Ok for V2b

(c) 2014 Golden Delicious Computers GmbH&Co. KG. Licensed under CC-BY-SA.

B2B to upper board

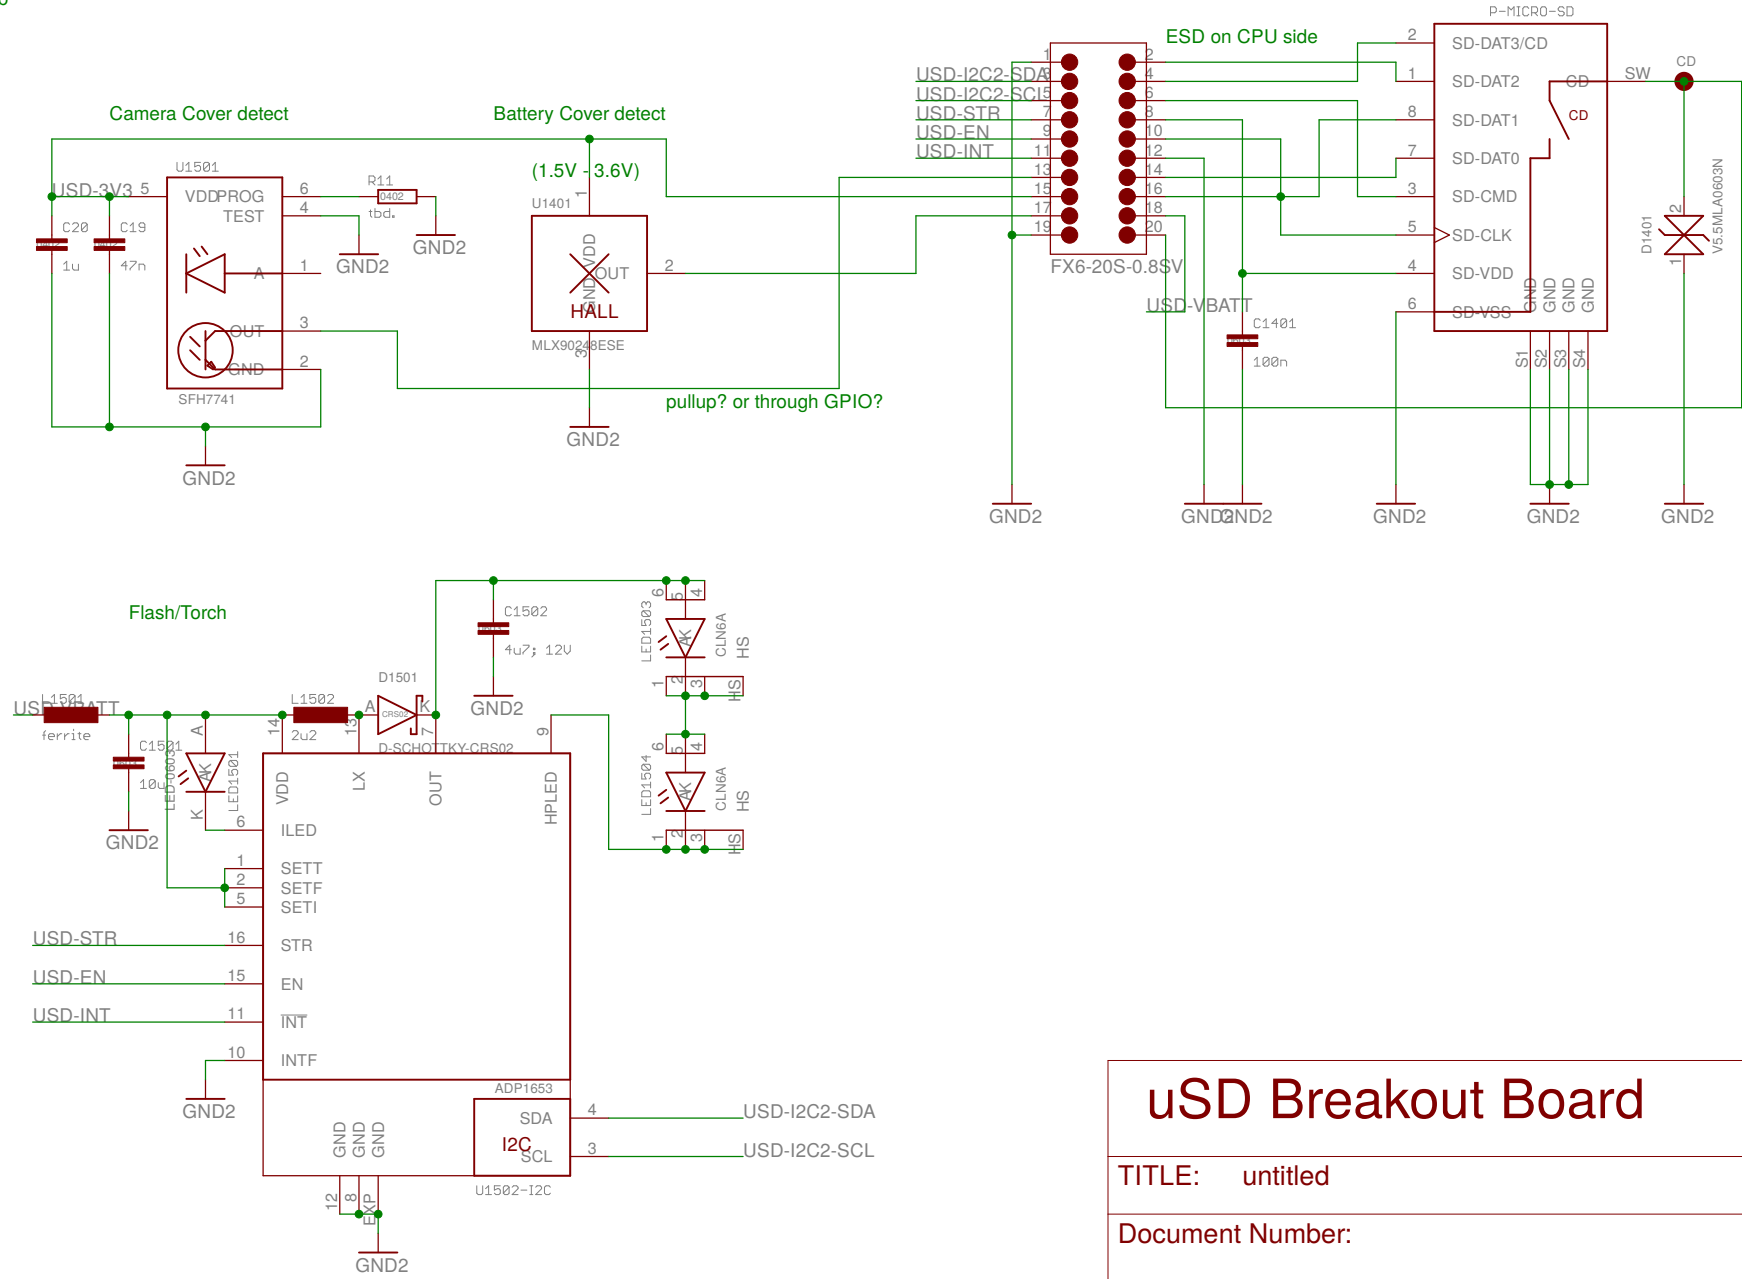
pin assignment tbd. (draft copied from GTA04Custom)

B2B to lower board

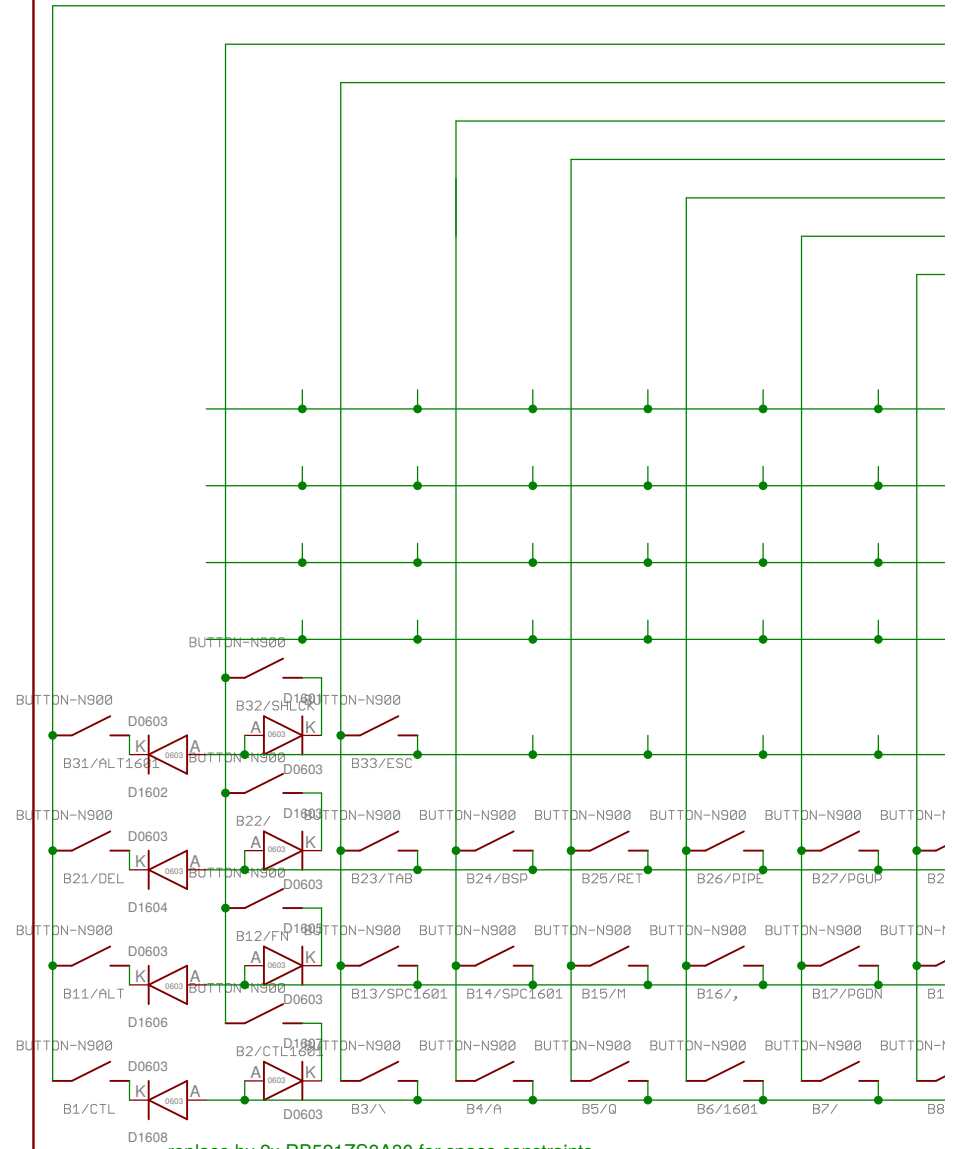
to be adjusted to lower board connector

no longer needed:
DSS
keyirq, penirq

additionally needed:
main camera CSI-A

lockswitch: 113 cam-focus: 58 cam-trigger: 69

Keypad

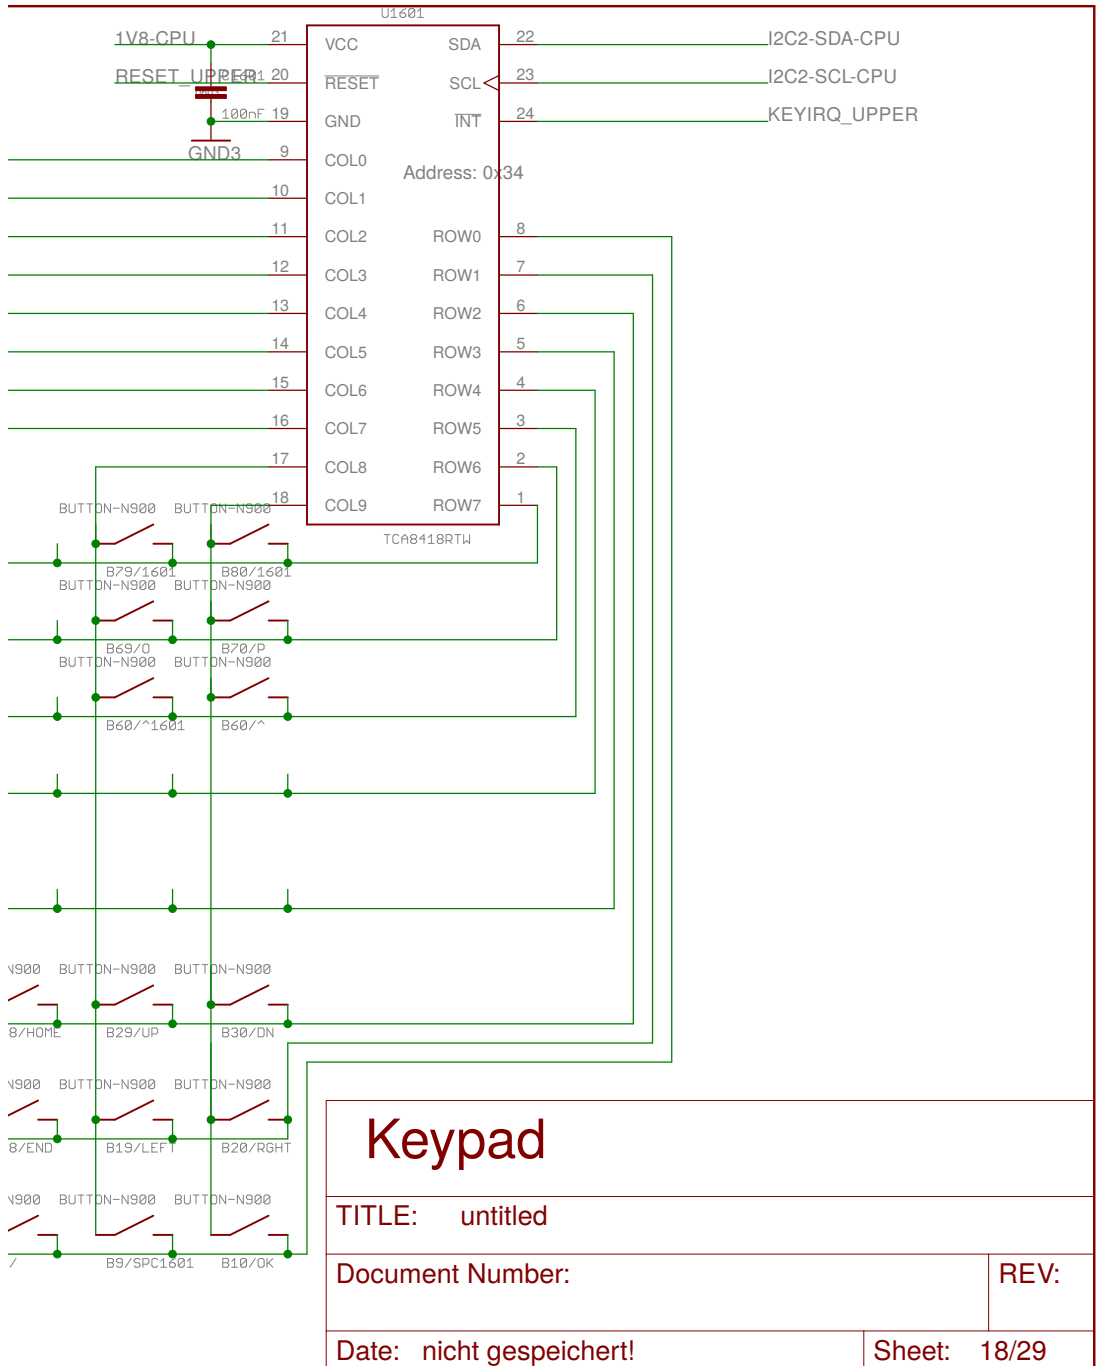
needs final tuning (which button on which position)

VOL+ and VOL- could drive FETs sitting in the matrix

replace by 2x RB521ZS8A30 for space constraints

CPU + PoP RAM/NAND

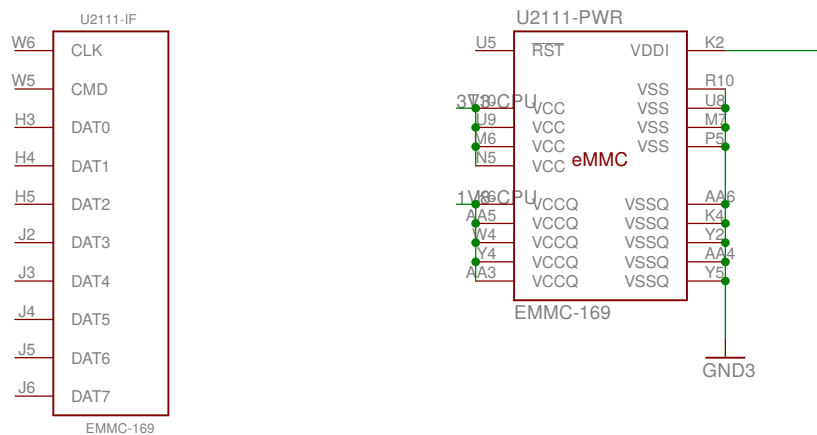
POP or eMMC or both?

PMU+Codec

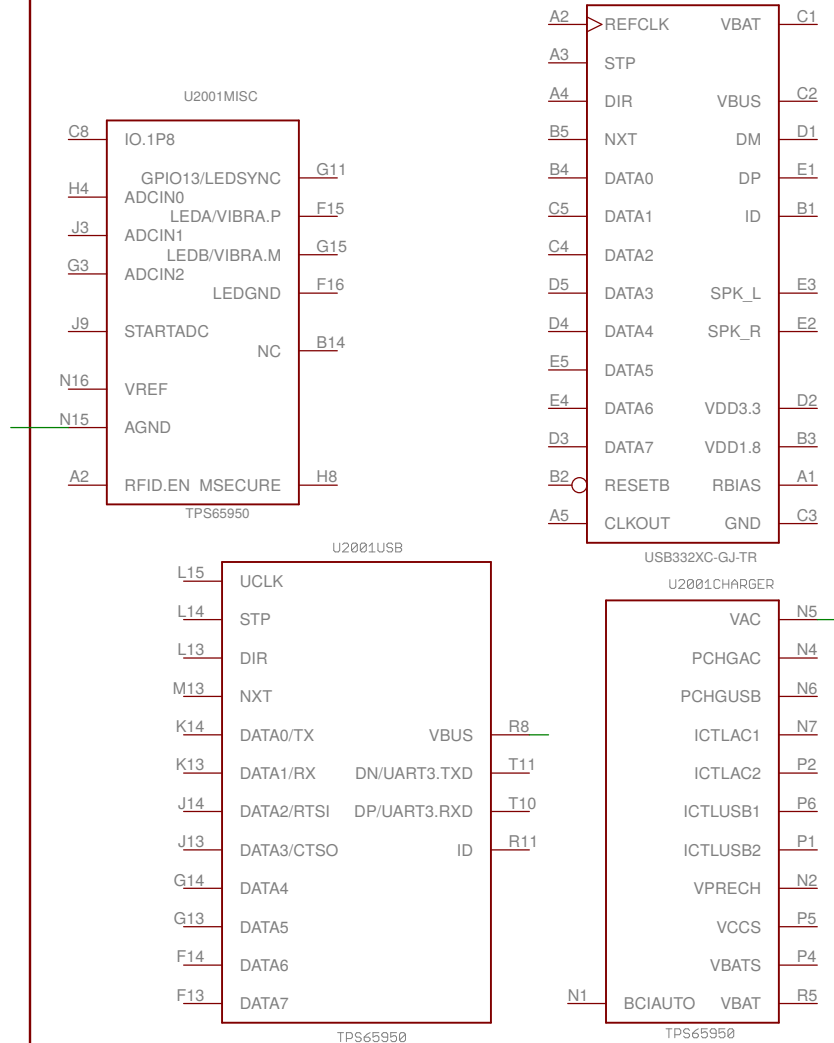
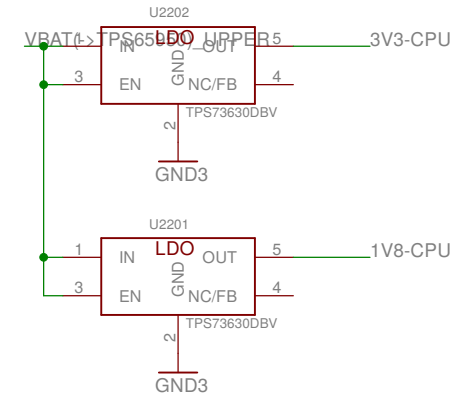
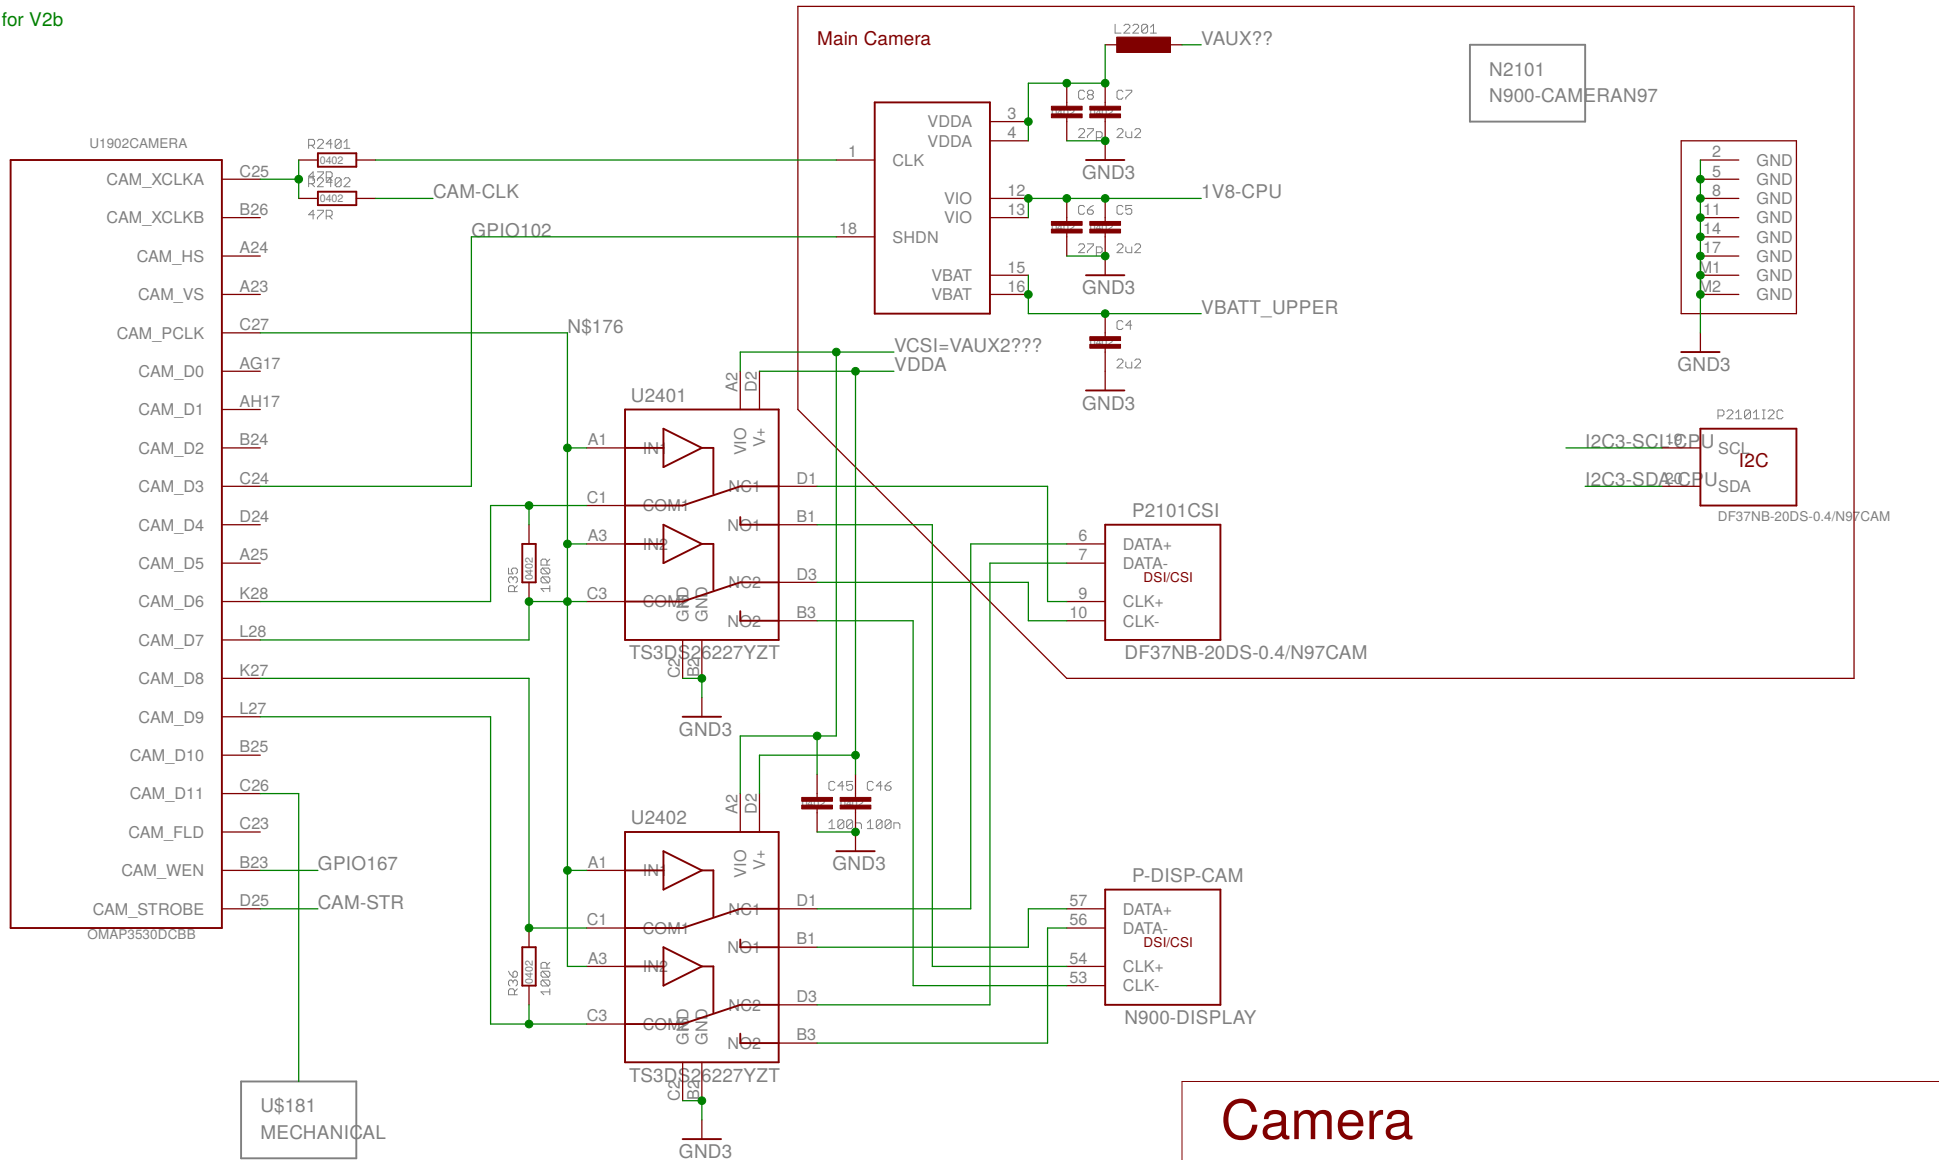
should drive TPS65950

simple capless 400mA LDO for TPS65950 substitute

BB-XM Adapter

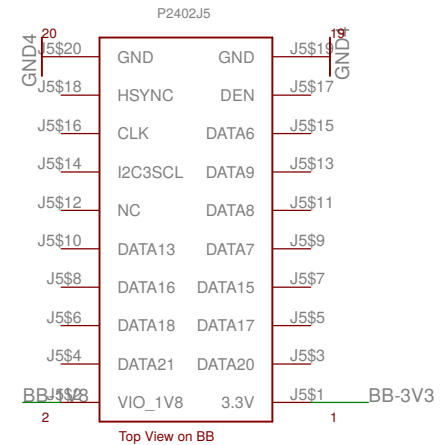
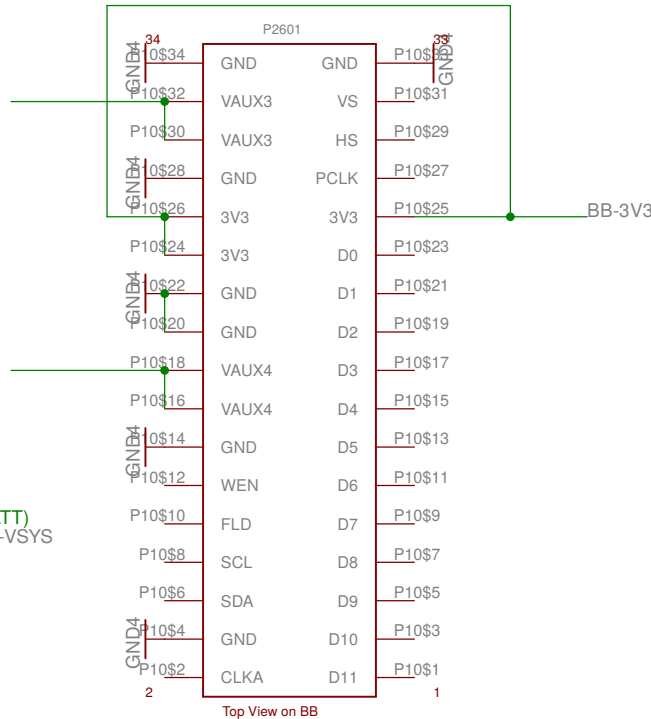
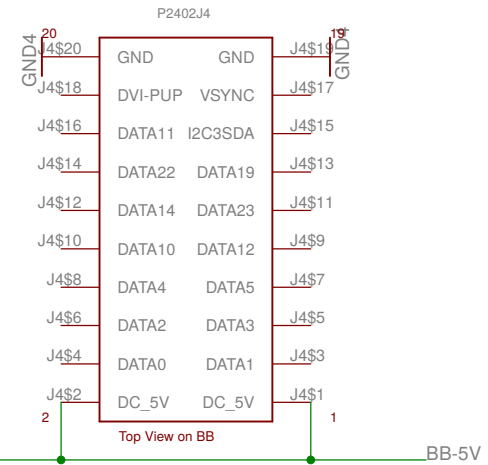
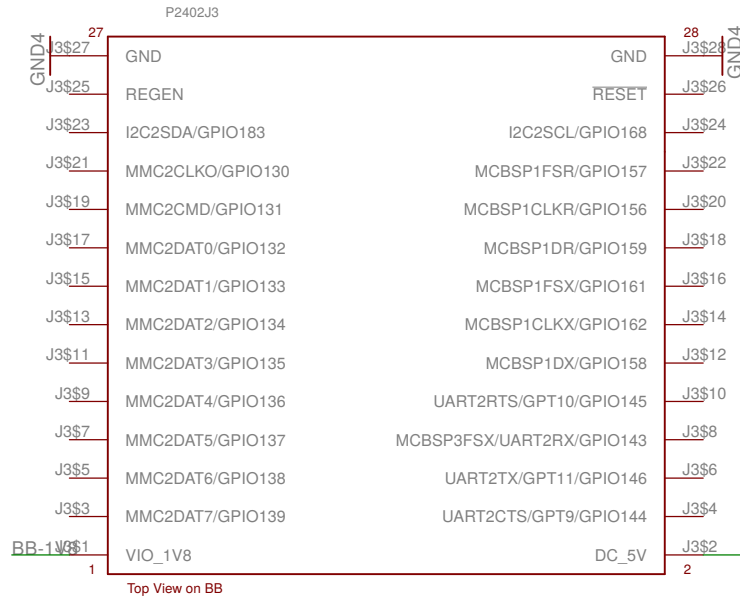
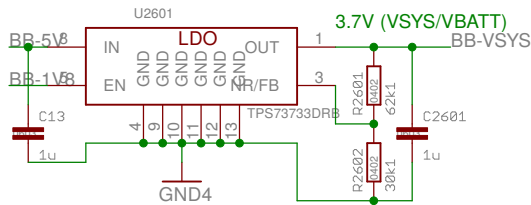
1v8???

reverse?
